6404 & 6406 9TH AVE NE  
Design Recommendation Meeting  
November 9, 2015

DPD PROJECT #3019700

EARLY DESIGN GUIDANCE | JUNE 1, 2015

1. ADJACENT DEVELOPMENT AND HEIGHT, BULK & SCALE

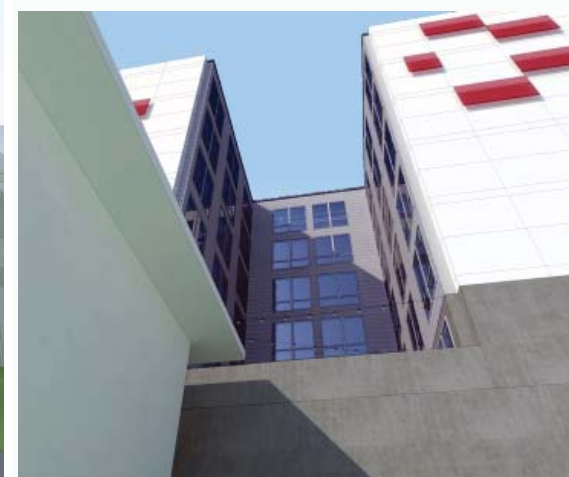
The Board discussed the massing and bulk of the three options presented and stated that Option 2 and Option 3 created the least privacy conflicts with the adjacent property. The Board noted that the only major break in mass in the applicant's preferred option was the south-facing courtyard and that break would not be easily visible from the street.

- a. The Board stated that respect for adjacent uses and neighboring properties should be a priority and directed the applicant to further develop the massing along the northern property line to be mindful and respond to the existing building located 5 feet from property line. For the Recommendation meeting, the applicant should study and provide additional analysis on the relationship to the immediate context, taking into consideration the existing window placement and amenity space of the building to the north. The applicant should demonstrate how the massing has responded to the immediate context. (CS1-B, CS2-D, DC2-A,B,&C)

- a. The proposed building is located just off the north and the south property lines. The neighboring structure to the north has a 2.5-story portion of the building located 5 ft. north of the project's north property line. To the south, the neighboring structure is a 2.5-story house that is located 3-4 ft. south of the project's south property line. The relationship of these adjacent structures have been studied relative to the proposed project—please see pages 43 through 45.

Privacy issues, height, bulk and scale along the north and south façades of the proposed building in relation to the neighbors have been addressed with the following architectural solutions:

- No windows are facing the neighbor's south-most wall. Windows have been strategically located for privacy.
- A railing in lieu of a solid parapet
- Change in siding pattern with a lighter color on the top floor

- The north and south top corners of the building step back.
- Building incorporates modulation to break up the massing of the overall structure.
- Primary siding is painted fiber-cement panels in a grid pattern that includes a playful color pattern along the top of the building where the structure is most visible from the neighbor and the rights-of-way.

- Lighting on the roof deck and courtyard will be directed inward and shielded such that no glare will spill over to adjacent neighbor lots.
- Green roof is proposed to be planted at the roof deck perimeter to provide a privacy buffer to adjacent neighbors.

- Location of the stair and elevator penthouses, along with photovoltaic system, aids in creating a privacy buffer to the north.

### 2. MASSING & COURTYARD

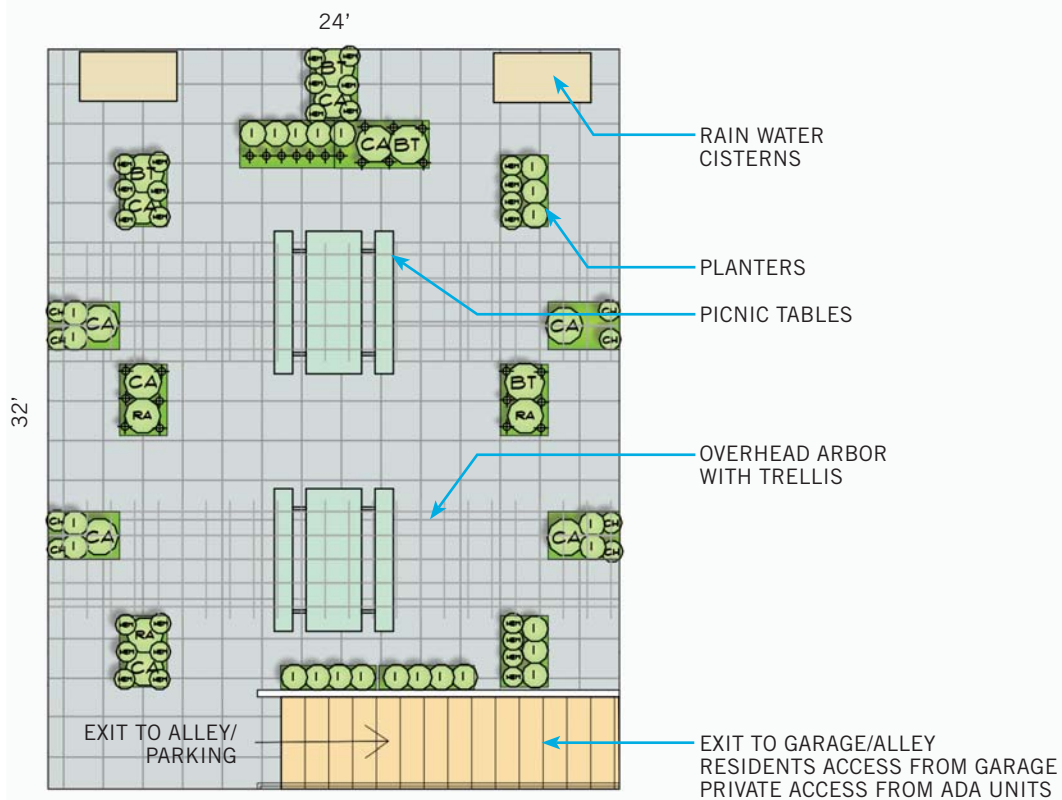
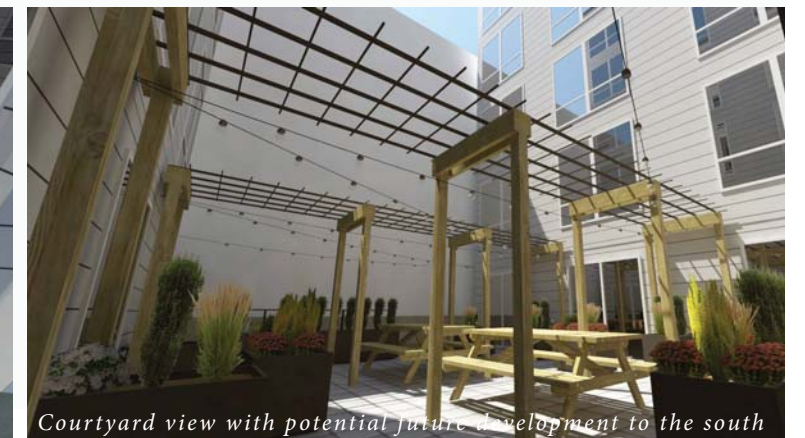
The Board discussed the differences between Option 2 and the applicant's preferred option (Option 3), primarily focusing on the differences between the two options, specifically the amount of blank walls, windows, courtyard, and relationship to the adjacent sites. The Board expressed general support for ground level scheme of the applicant's preferred Option and the composition of the upper levels of Option 2.

- The Board discussed the benefits of the upper level setbacks and unit layout in Option 2 because it allowed for additional windows and minimized blank walls along the north and south facades of the building. The Board directed the applicant to take cues from the upper level scheme in Option 2 and look for ways to incorporate additional windows and minimize blank walls into Option 3, while being mindful of the privacy of the adjacent development. (DC2-B, CS2-D, DC1-A)

- The south-facing courtyard presented in the applicant's preferred option was approximately 30 feet wide by 40 feet deep. The Board stated support for the size and orientation of the courtyard amenity space in the applicant's preferred option and noted that this courtyard location and size could remain successful even after the property to the south is redeveloped. The Board directed the applicant to provide additional detail on the courtyard including dimensions, conceptual landscaping, access and circulation. (CS1-B, DC3-B, DC4-D, PL2-A)

- EDG Option 2 utilized a 10 ft. setback from the north & south property lines to provide windows. Option 3 pushed units to the lot lines to provide an interior courtyard. Incorporating a north setback and north-facing units with windows into the preferred Option 3 would not leave enough space for a viable courtyard. In order to maintain the courtyard and privacy to the north, the proposed design does not include north-facing units. Please also note that the Building Code does not permit openings in walls located closer than 5 ft. to the property line.

The proposed design responds to the Board's concern regarding minimizing blank walls with the following architectural elements:

- Use of modulation
- Strategically located windows
- Finish patterns and colors to break down the expanse of the north and south facing walls
- The courtyard to the south divides the building into smaller portions.
- Setbacks: balconies at the top corner units on the west and east ends of the building add further interest and minimize the impact of height and mass.
- Privacy is maintained for both neighbors north and south with no windows directly facing adjacent units or common spaces.

- The courtyard proposed for the building measures 24 ft. by 32 ft. and is accessed directly by the units facing the courtyard on the second floor. See also page 29.
  - Shared exit from the courtyard via stairs to the alley level—stairs are located at the south edge of the courtyard providing some privacy to the neighbor's yard to the south.
  - The courtyard is intended to be a semi-private amenity space utilized by the adjacent unit tenants.
  - The roof deck will be used as the common amenity space for the majority of the tenants.
  - Fully paved decking surface with large tables for gathering
  - Landscape planters are located in front of each unit's access to the deck to provide some privacy outside the main circulation space around the tables.
